**TOWN OF NEWBURGH
PLANNING BOARD
TECHNICAL REVIEW COMMENTS**

PROJECT NAME: PATTON RIDGE FINAL SUBDIVISION
PROJECT NO.: 2012-18
PROJECT LOCATION: SECTION 47, BLOCK 1, LOT 44
REVIEW DATE: 1 APRIL 2022
MEETING DATE: 7 APRIL 2022
PROJECT REPRESENTATIVE: KIRK ROTHER, P.E.

PATTON RIDGE
TOWN OF NEWBURGH, ORANGE COUNTY, NEW YORK
PROJECT TITLE
GRADING AND DRAINAGE PLAN
DRAWING TITLE

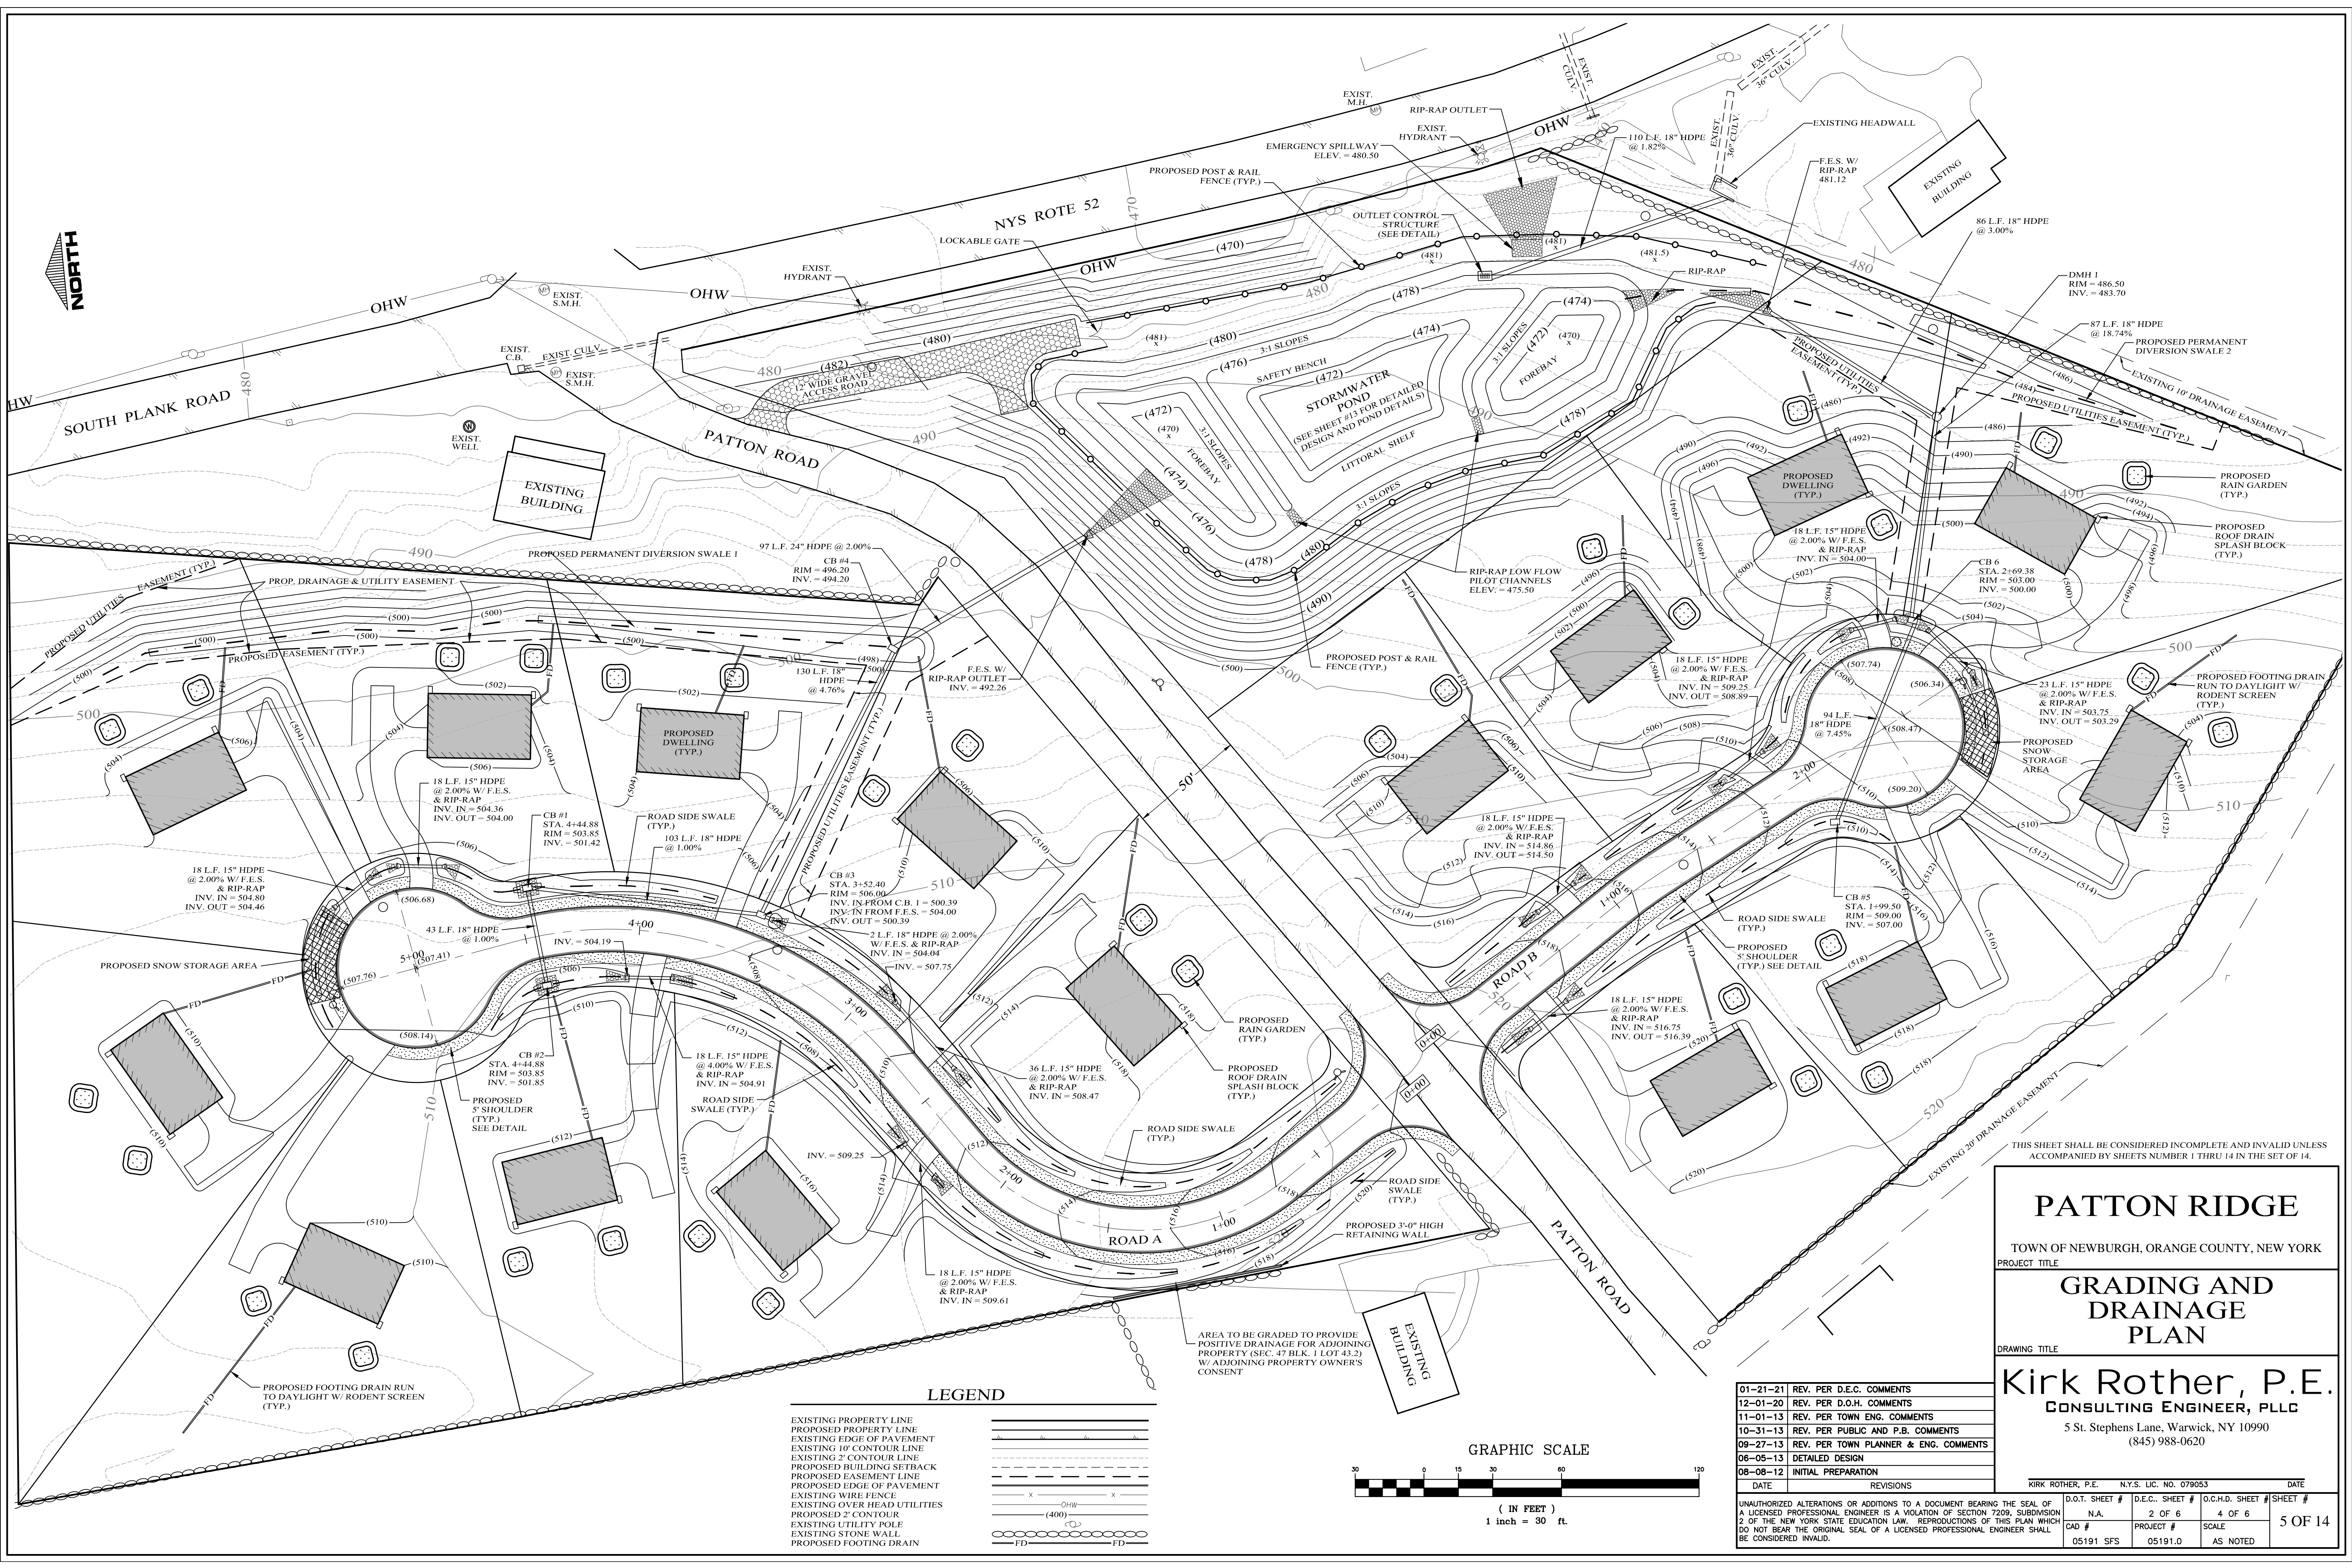
14. Recreation fees in compliance with the Town's schedule are required.
15. A note appears on Sheet 5 of 14 regarding off-site grading activities. Section 47, Block 1, Lot 43.2, status of owner's consent for off-site grading should be addressed.
